Form 3160-5
(June 2015)UNITED STATES
DEPARTMENT OF THE INTERIOR
BUREAU OF LAND MANAGEMENT**SUNDRY NOTICES AND REPORTS ON WELLS**
*Do not use this form for proposals to drill or to re-enter an abandoned well. Use form 3160-3 (APD) for such proposals.*FORM APPROVED
OMB NO. 1004-0137
Expires: January 31, 20185. Lease Serial No.
NMLC057210

8. Well Name and No.
MCA UNIT 2749. API Well No.
30-025-2373110. Field and Pool or Exploratory Area
MALJAMAR11. County or Parish, State
LEA COUNTY, NM**SUBMIT IN TRIPLICATE - Other instructions on page 2**

MCA 274

Permanent Abandonment of Federal Wells
Conditions of Approval (LPC Habitat)

CURRENT SCHEMATIC

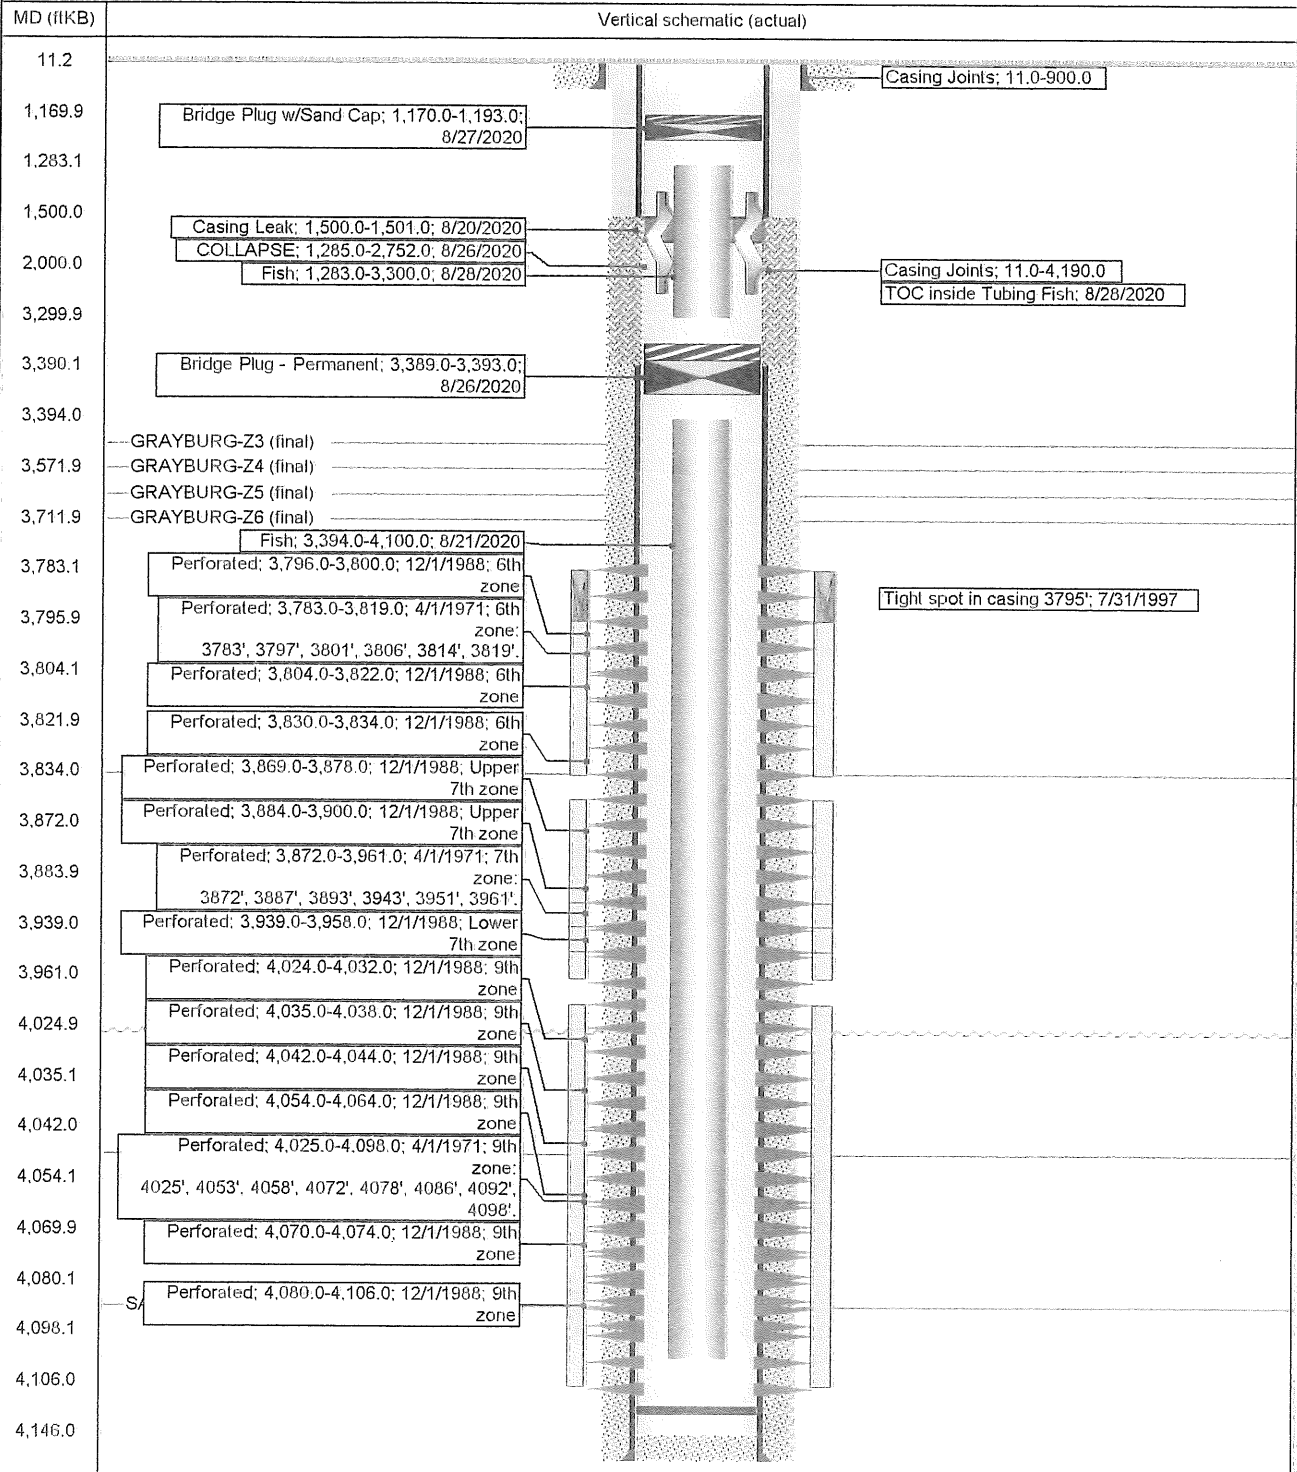
Make every effort to clean out well bore to 2000'. Perf and SQZ cmt. from 2000-1880'. WOC Tag. If can't be achieved Contact J. Amos prior to proceeding & approve

Below ground level dry hole marker required
